Mehlville R-IX School District
2900 Lemay Ferry Road
St. Louis, Missouri 63125

SUBJECT: Addendum No. 3 to the Bidding Documents for:

Mehlville School District – Bus Transportation Facility Project

C4.0

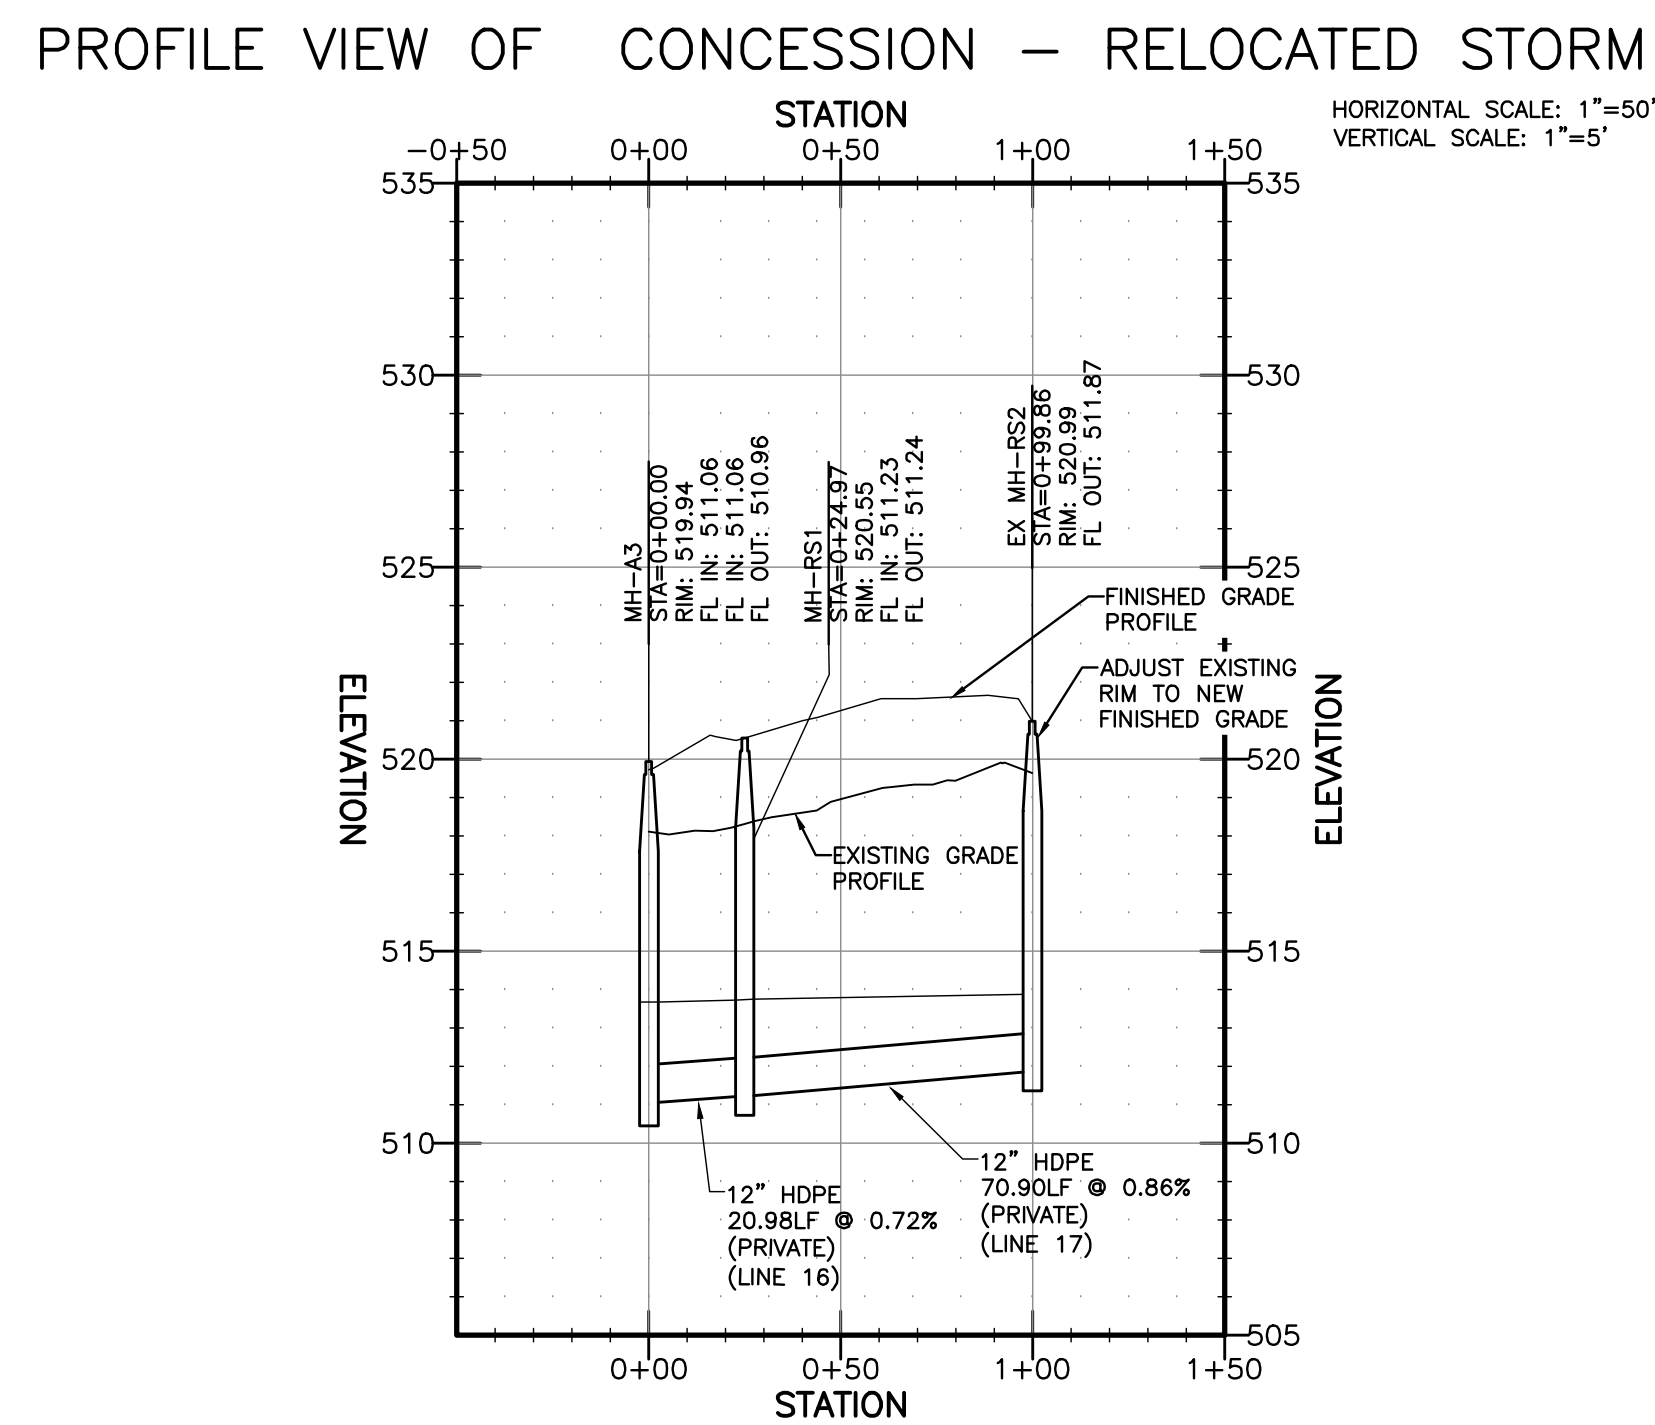
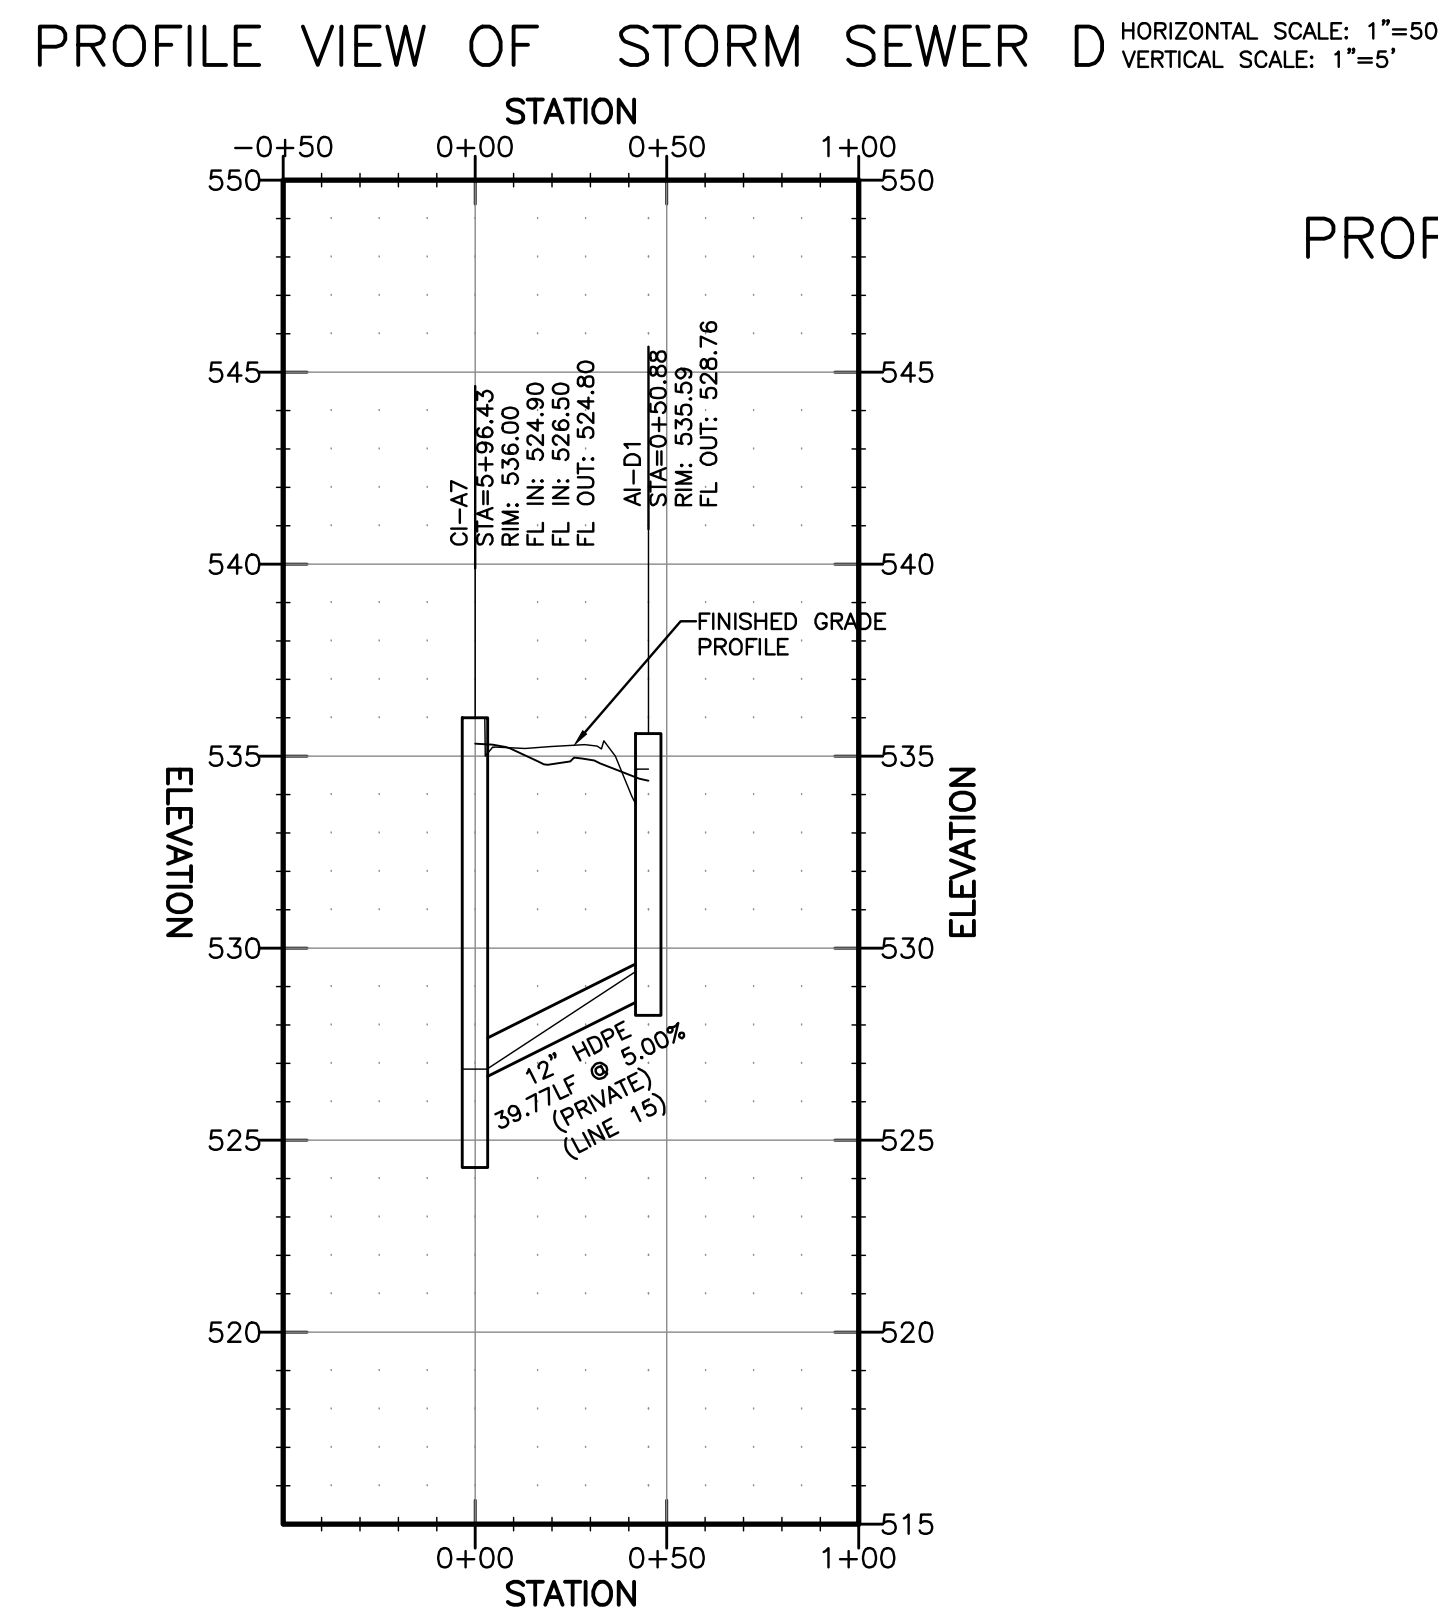
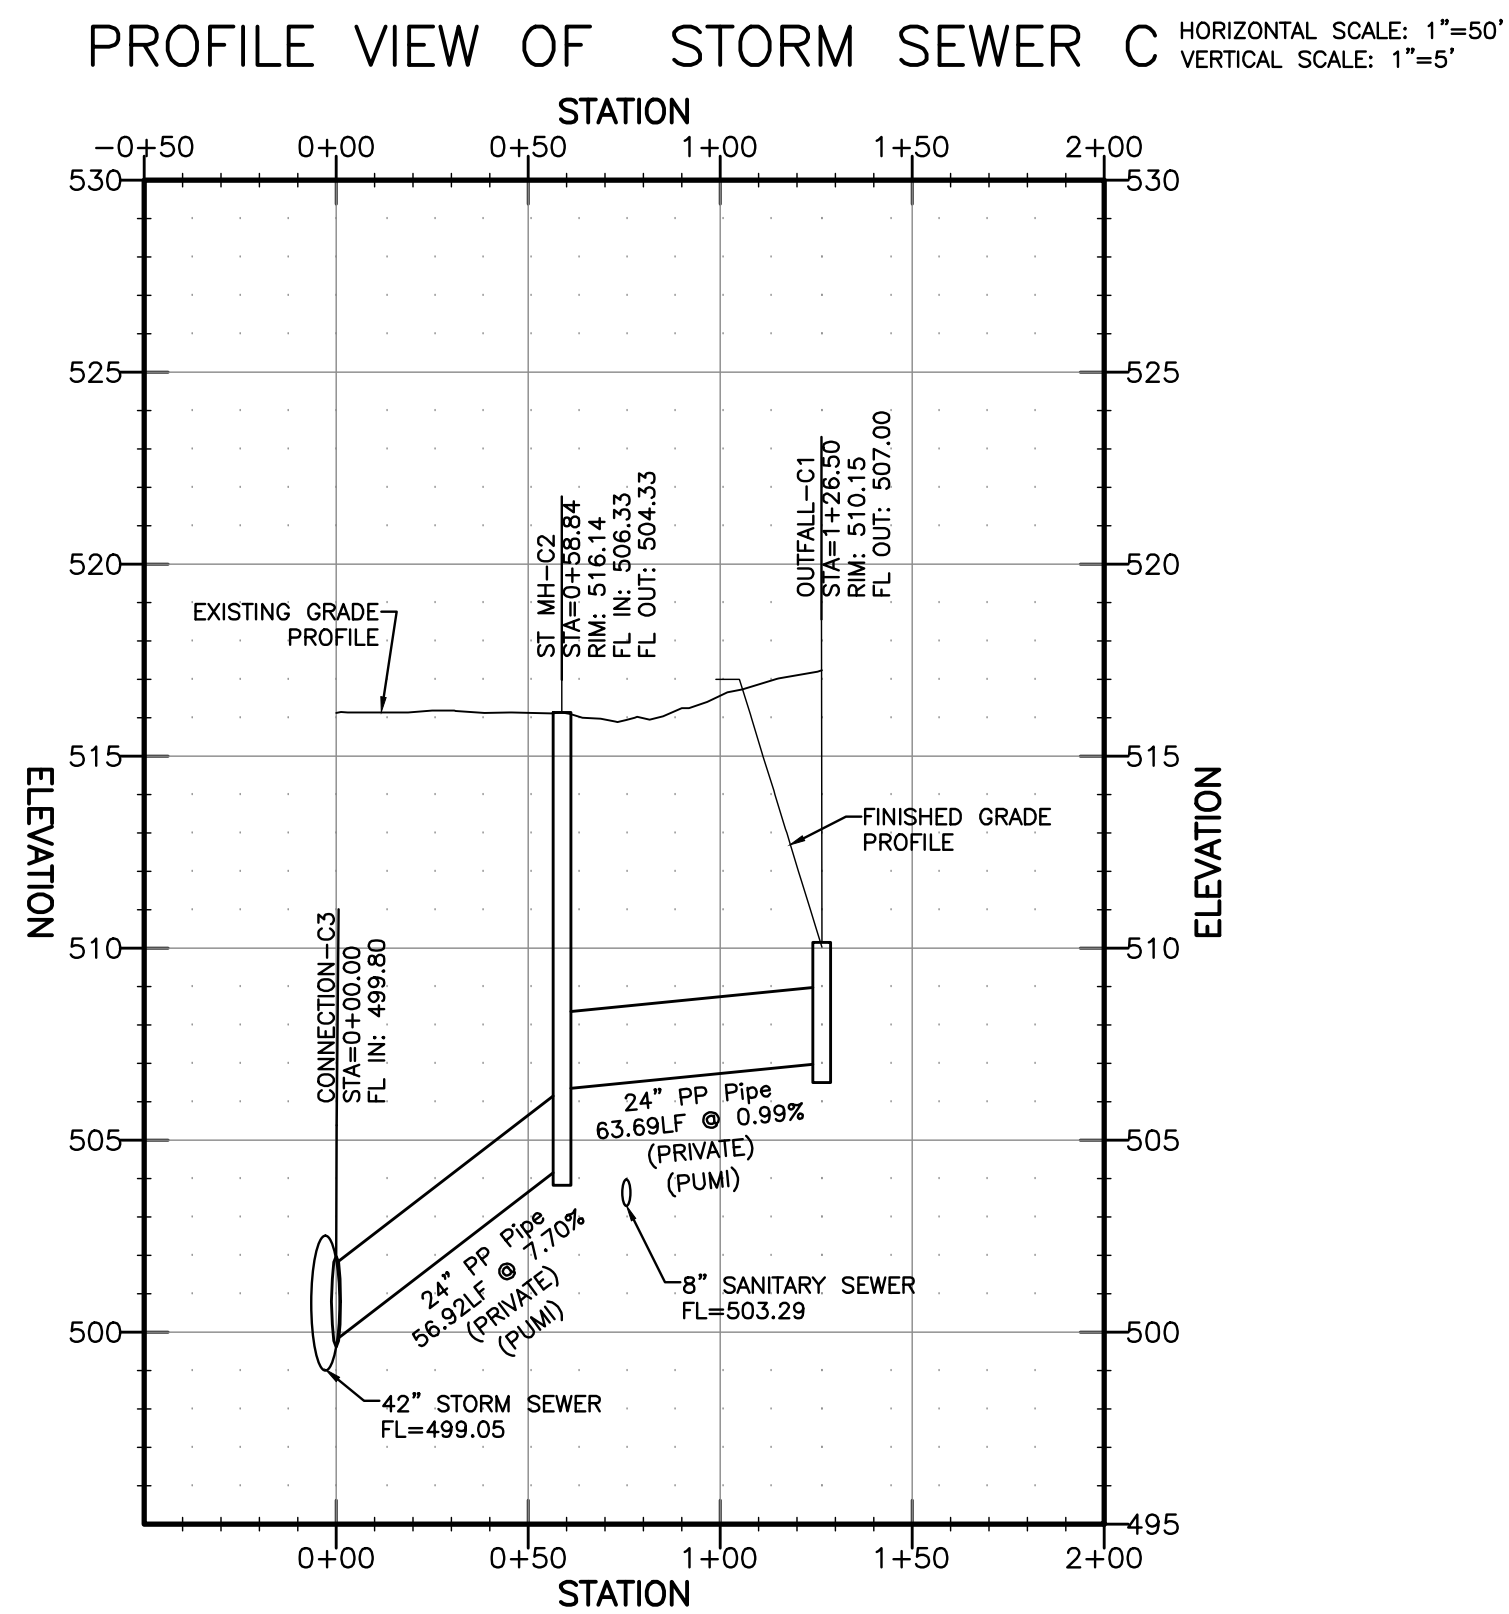
- a. **ADDED** foundation drain & tie in location to manhole
- 8. Sheet C5.0 - PROFILES SHEET
 - a. **UPDATED** profile callouts for new foundation drain connection to manhole
